Staff Report

To: Development Review Board
From: Michael Giguere, City Planner
Meeting Date: April 17th, 2025
Subject: Final plat review for a three-lot subdivision for one residential lot and two lots for future development; road connection of Taft Street to Meadow Terrace in the R1 District by Center for Technology Essex, owners.
File: SP# 7.2024.1 and SP# 7.2024.2

Three-lot subdivision and boundary line adjustment of the 6.11-acre lot located at the end of Taft Street and road connection of Taft Street to Meadow Terrace for the continuation of the Residential Building Trades program at the Center for Technology, Essex (CTE). The new road connection is proposed to be named "Meadow Terrace" to meet Vermont state addressing standards. Proposed new lot 6A will be the location of the next home, and lots 7A and 8A will remain undeveloped until plans for future subdivision are finalized.

CD-2

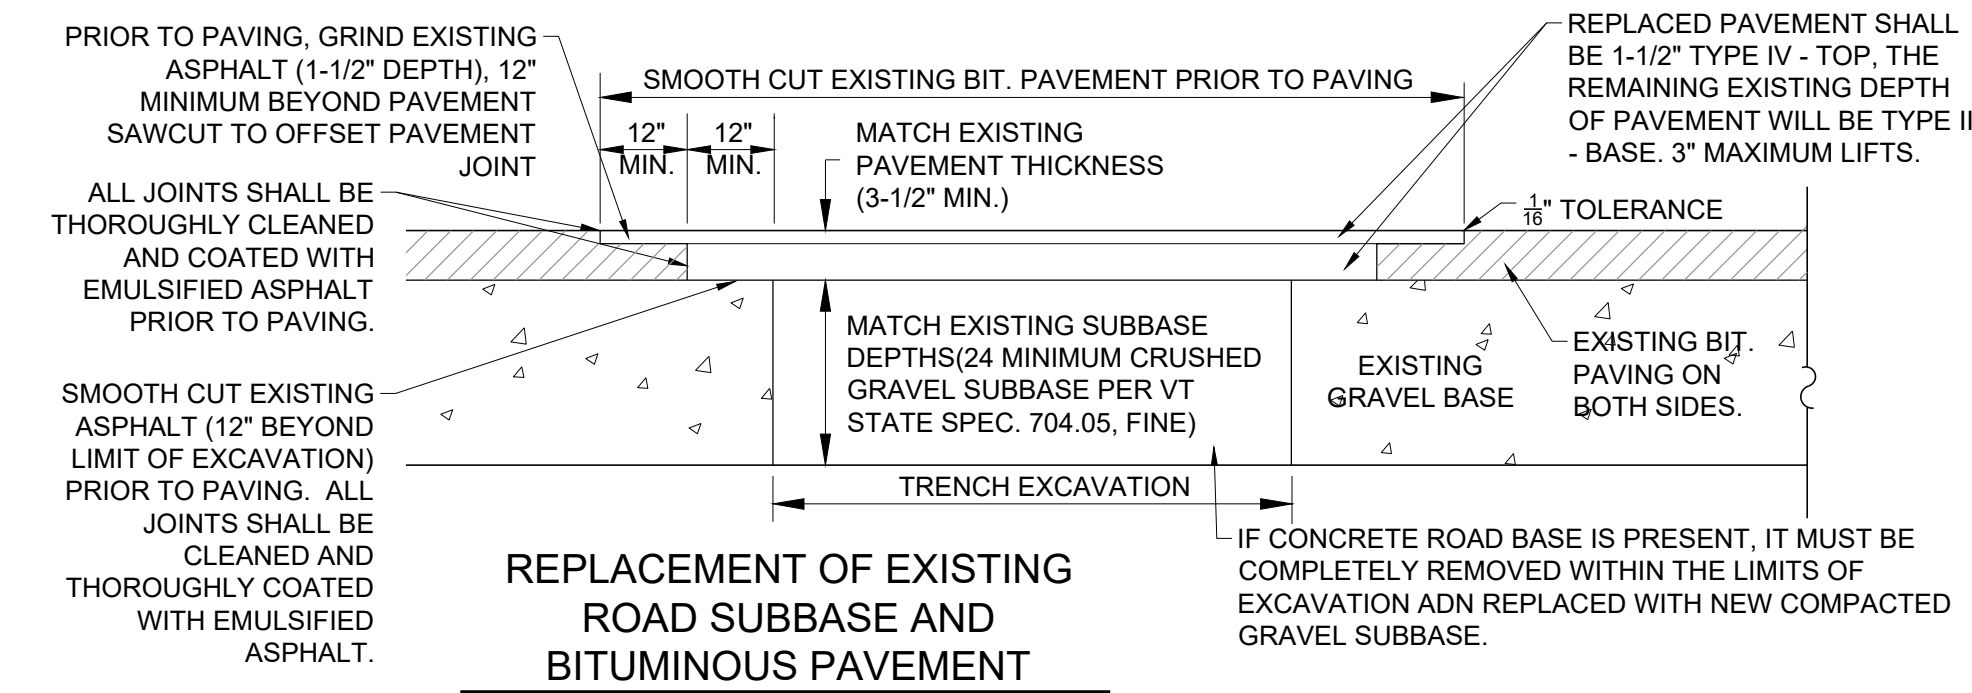
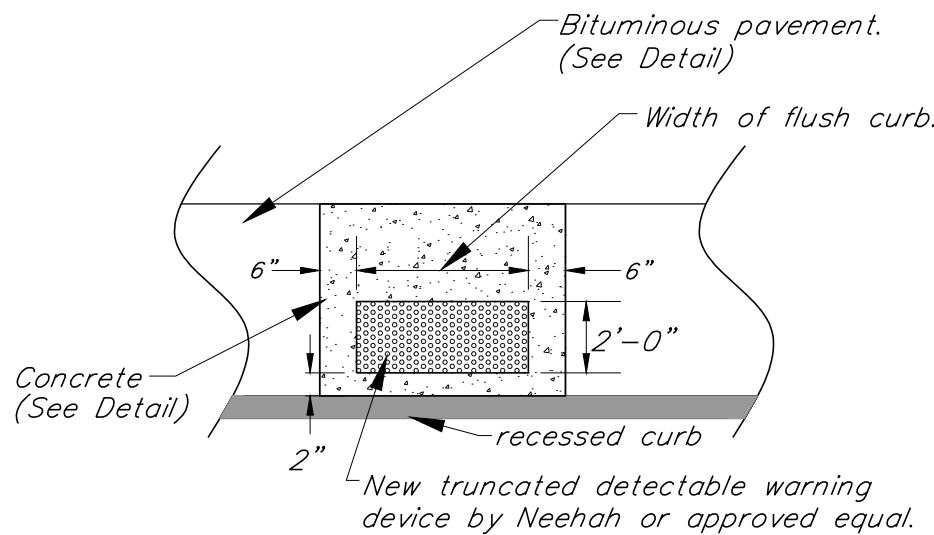
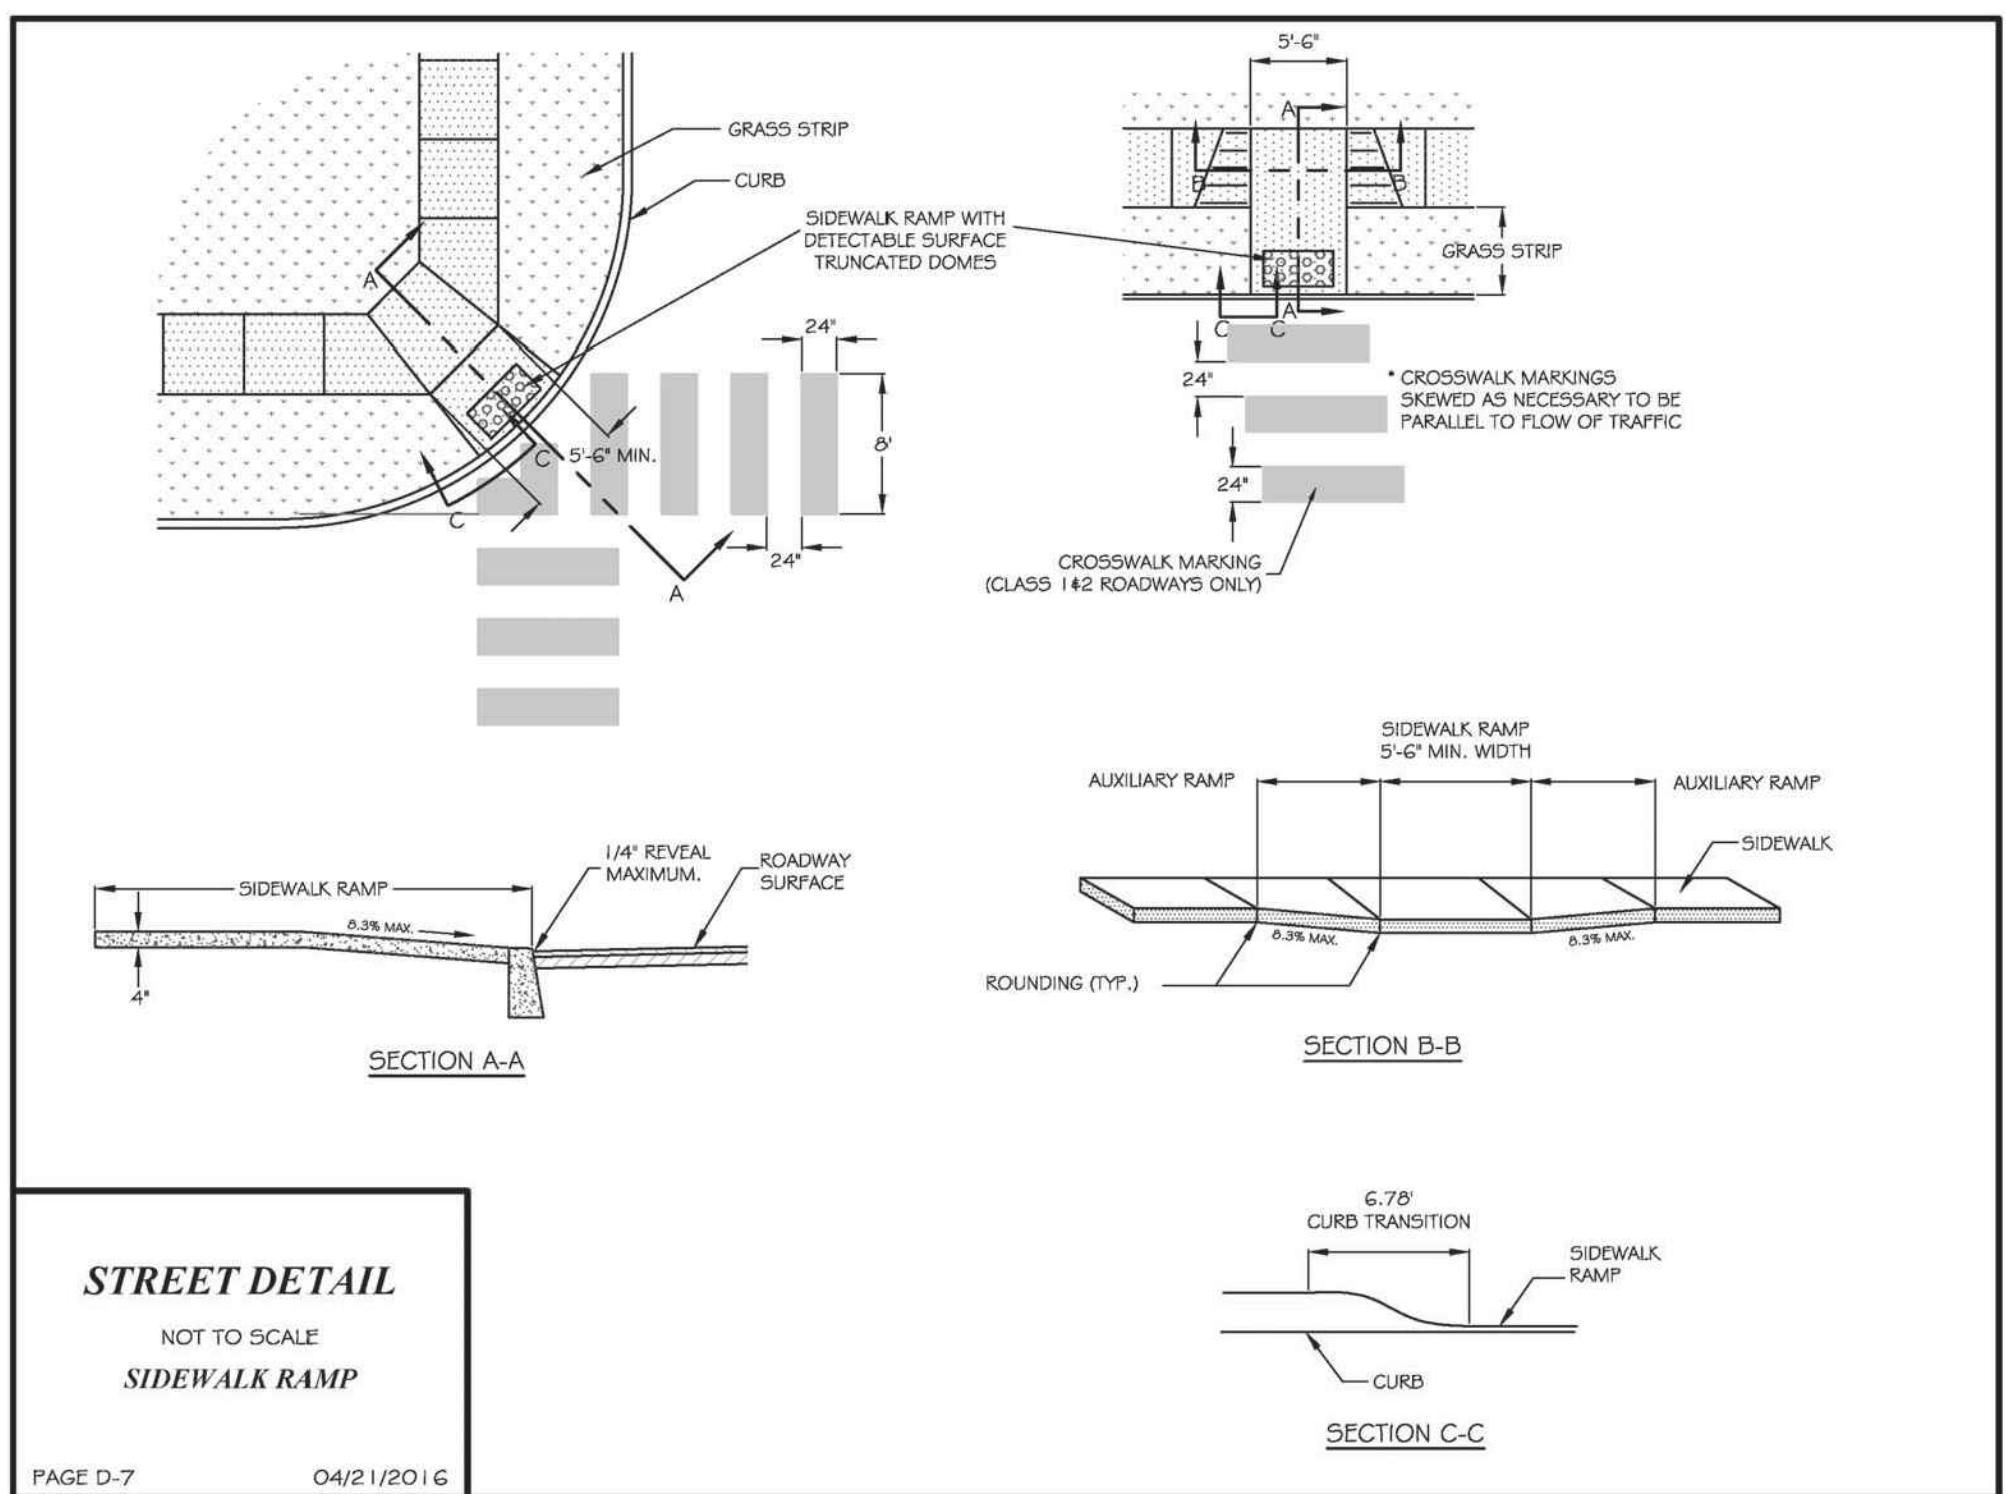
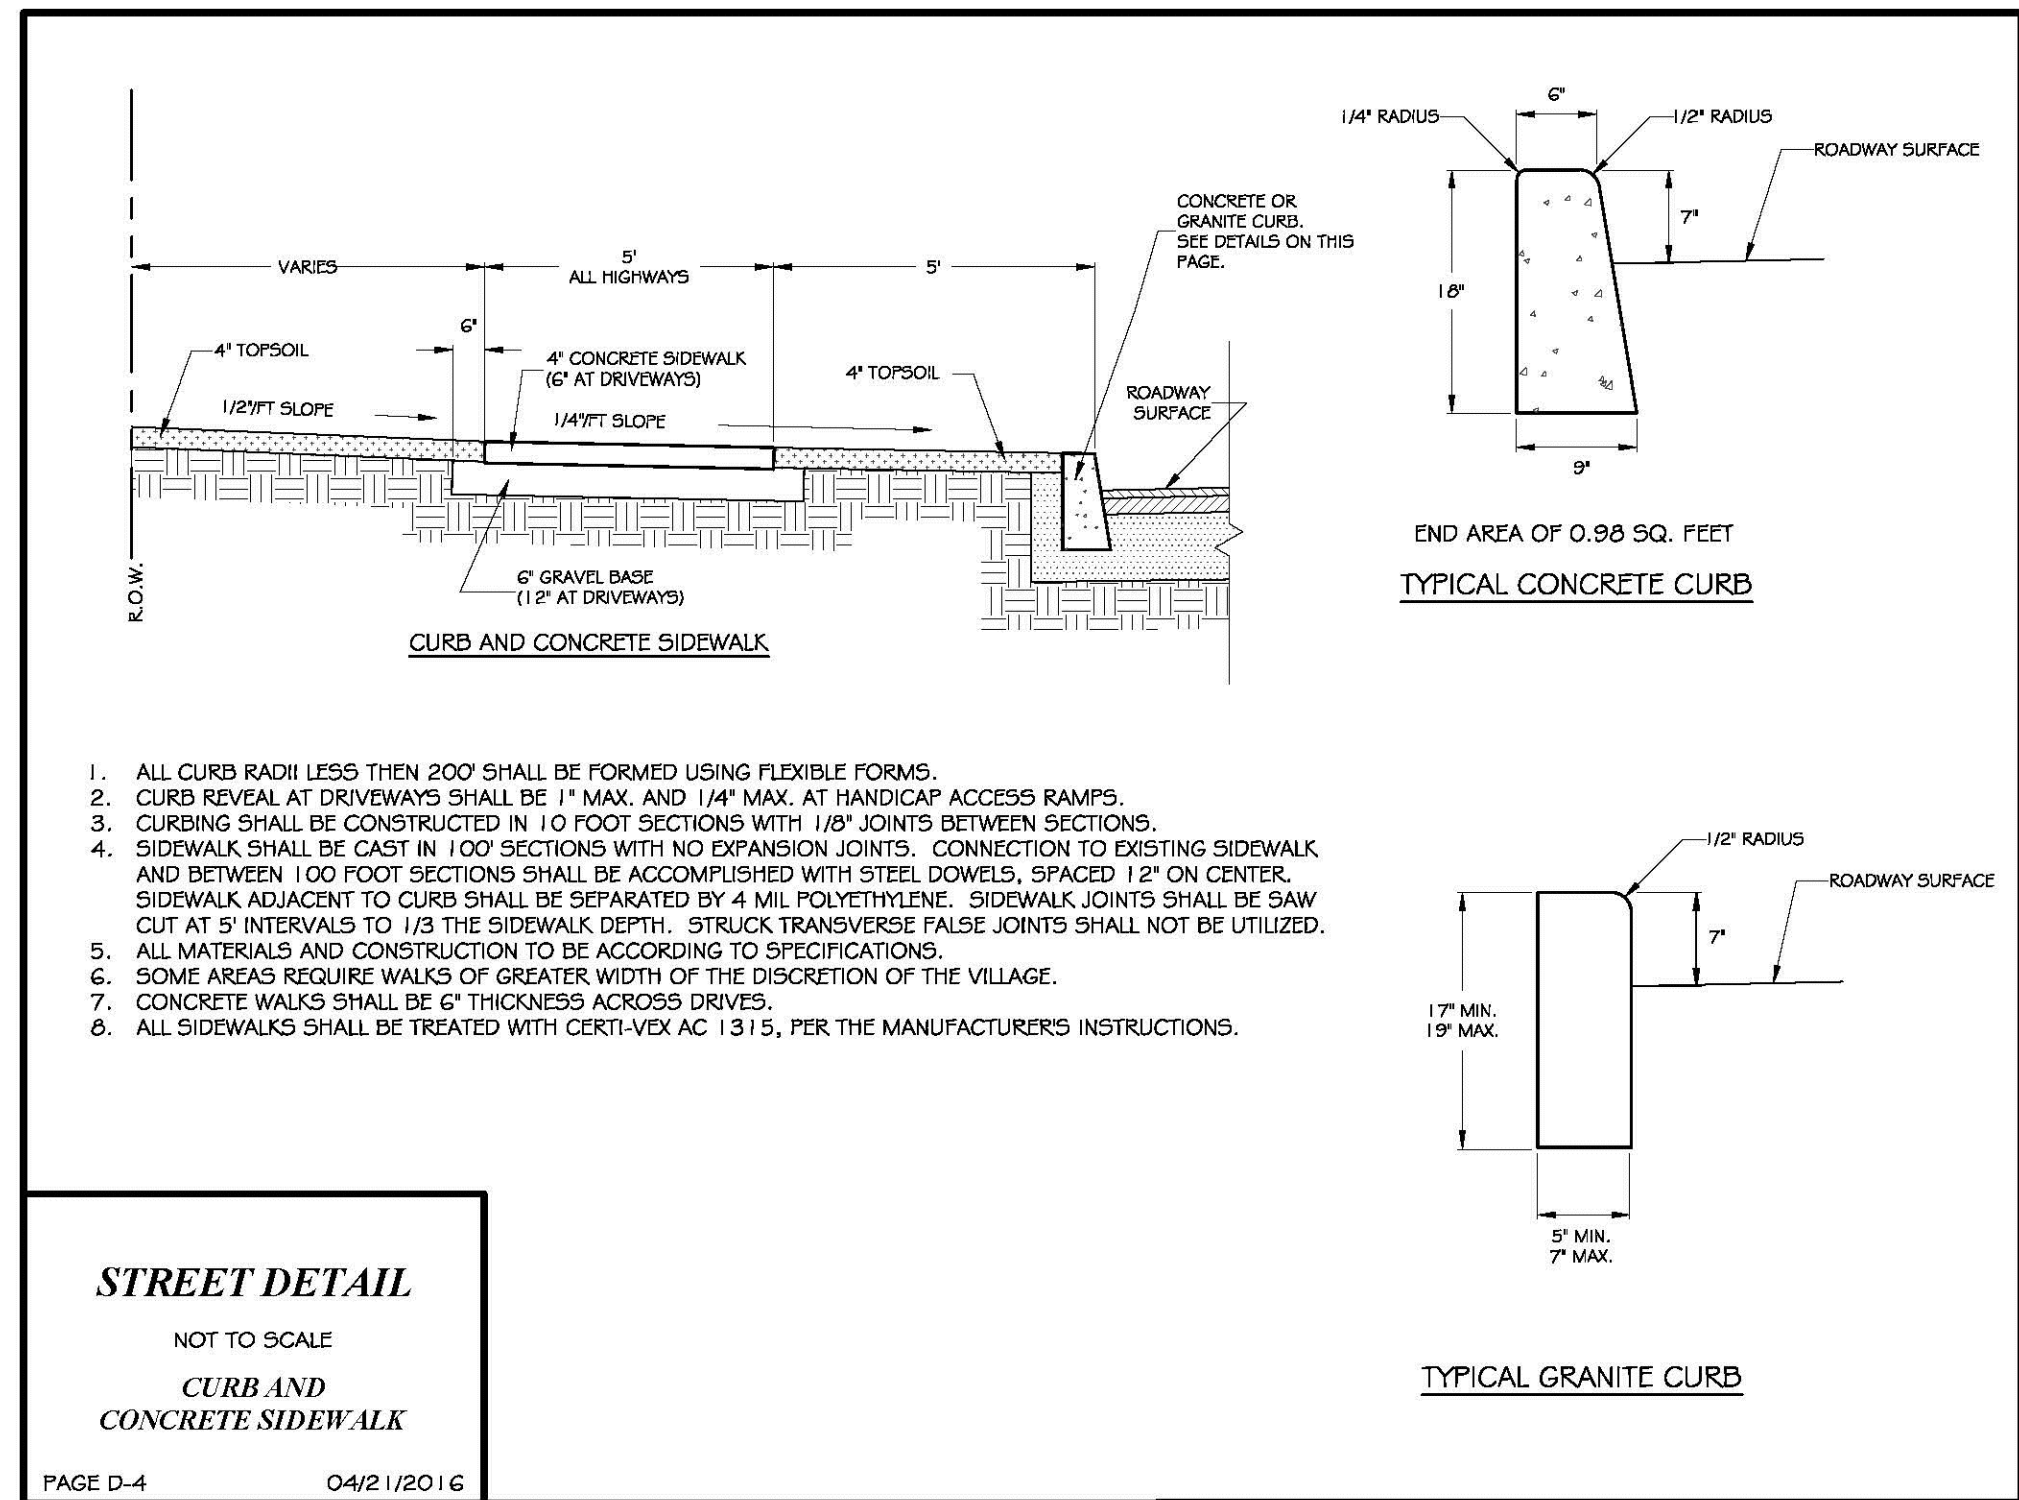
- 6) On Sheet CD-2, the Typical “Local Residential Street” Cross Section detail sidewalk cross section does not meet the LDC requirements. This detail should be revised to reflect the requirements shown on Page D-4 of the LDC.

- 7) On Sheet CD-3, the Cross Section details for the “New Thickened Concrete Walk Detail” and the “New Concrete Walk Detail” do not meet the LDC requirements. These details should be revised to reflect the requirements shown on Page D-4 of the LDC.

- 8) On Sheet CD-3, the Replacement of Existing Road Subbase and Bituminous Pavement detail includes a note stating “*Match existing pavement thickness (7” max)*”. This note should be revised to state “*Match existing pavement thickness (3-1/2” minimum)*”.

- 9) On Sheet CD-3, the notes for the Replacement of Existing Road Subbase and Bituminous Pavement detail appear to apply to the repair of potholes. The applicant should provide clarification and make revisions as needed.

- 10) On Sheet CD-3, note #6 of the Replacement of Existing Road Subbase and Bituminous Pavement detail should be revised to state “*Fill top of hole with Type IV bituminous concrete and compact in lifts no more than 2” thick.*”, not 2’ thick as currently written.

- 11) On Sheet CD-3, the Replacement of Existing Road Subbase and Bituminous Pavement detail includes a note stating “*If concrete road base is present, it must be replaced with 3,500 psi concrete to match existing conditions. Dowel existing concrete and new concrete with #4 rebar 18” o.c. embed rebar in existing and new concrete 9” deep.*” This note should be revised to state “*If concrete road base is present, it must be completely removed within the limits of the excavation and replaced with new compacted gravel subbase.*”

- 12) On Sheet CD-3, the Curb Taper – 6’ or 3’ detail does not meet the LDC requirements. Depending on the curb height, the taper will need to be longer than 6’ or 3’ in order to comply with accessibility requirements.

We have added the transition detail to Sheet CD-2 of the plan set.

- ✓ **This comment has been addressed.**
- 6) On Sheet CD-2, the Typical “Local Residential Street” Cross Section detail sidewalk cross section does not meet the LDC requirements. This detail should be revised to reflect the requirements shown on Page D-4 of the LDC.

- ✓ **This comment has been addressed.**
- 7) On Sheet CD-3, the Cross Section details for the “New Thickened Concrete Walk Detail” and the “New Concrete Walk Detail” do not meet the LDC requirements. These details should be revised to reflect the requirements shown on Page D-4 of the LDC.

- ✓ **This comment has been addressed.**
- 9) On Sheet CD-3, the notes for the Replacement of Existing Road Subbase and Bituminous Pavement detail appear to apply to the repair of potholes. The applicant should provide clarification and make revisions as needed.

- ✓ **This comment has been addressed.**
- 10) On Sheet CD-3, note #6 of the Replacement of Existing Road Subbase and Bituminous Pavement detail should be revised to state "Fill top of hole with Type IV bituminous concrete and compact in lifts no more than 2" thick.", not 2' thick as currently written.

- ✓ **This comment has been addressed.**
- 11) On Sheet CD-3, the Replacement of Existing Road Subbase and Bituminous Pavement detail includes a note stating "If concrete road base is present, it must be replaced with 3,500 psi concrete to match existing conditions. Dowel existing concrete and new concrete with #4 rebar 18" o.c. embed rebar in existing and new concrete 9" deep." This note should be revised to state "If concrete road base is present, it must be completely removed within the limits of the excavation and replaced with new compacted gravel subbase."

- ✓ **This comment has been addressed.**
- 12) On Sheet CD-3, the Curb Taper – 6' or 3' detail does not meet the LDC requirements. Depending on the curb height, the taper will need to be longer than 6' or 3' in order to comply with accessibility requirements.
